**APPLICATION BY NORTH FALLS OFFSHORE WINDFARM LIMITED**  
**FOR AN ORDER GRANTING DEVELOPMENT CONSENT FOR THE NORTH FALLS OFFSHORE**  
**WINDFARM PROJECT**  
**(REF: EN010119)**

**DEADLINE 2**  
**WRITTEN REPRESENTATION BY THE PORT OF**  
**LONDON AUTHORITY**

Figure 2 – Northern Approaches to the Port of London

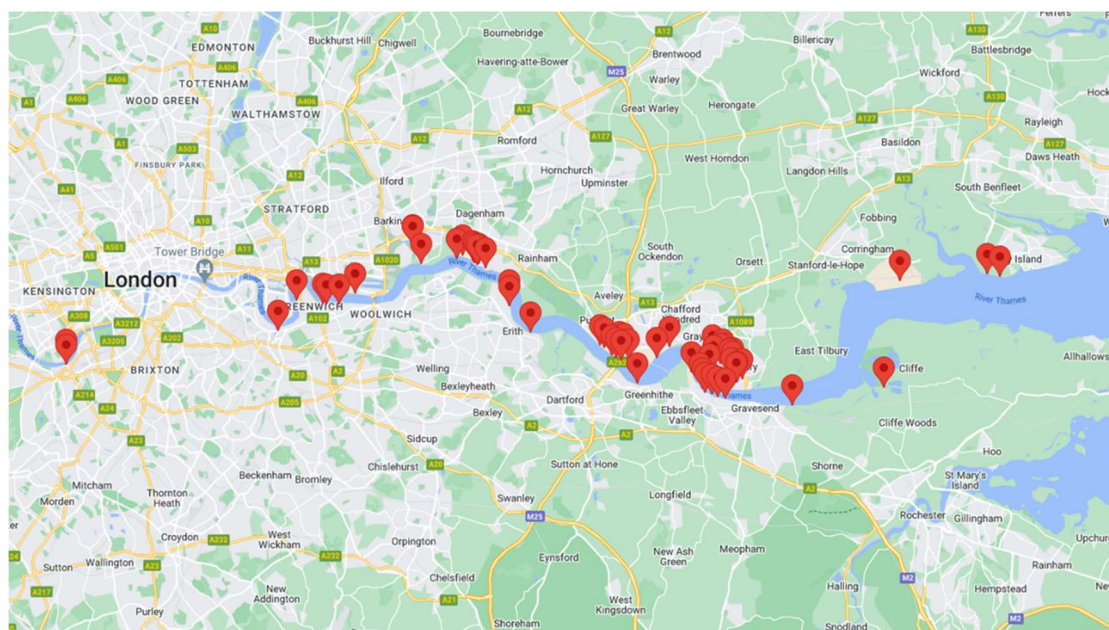
the PLA's Jurisdictional Limits to be the northern seaward approaches to the Port of London. These are the waters of navigational significance outside of and adjacent to the PLA's jurisdiction limits which deeper draughted vessels must pass through to get into the Port of London. For context when referring to deeper draughted vessels the port currently handles vessels up to 16.1m draught and, the minimum charted water depths are 18m (Trinity) and 16m (Sunk) below Chart Datum ("CD") where the OCC would cross the DWRs.

- 2.5 For the avoidance of doubt, other approaches to the Port of London are available for use by shallower draughted vessels, but these would not be impacted by the NF project and are therefore not included in Figure 2.
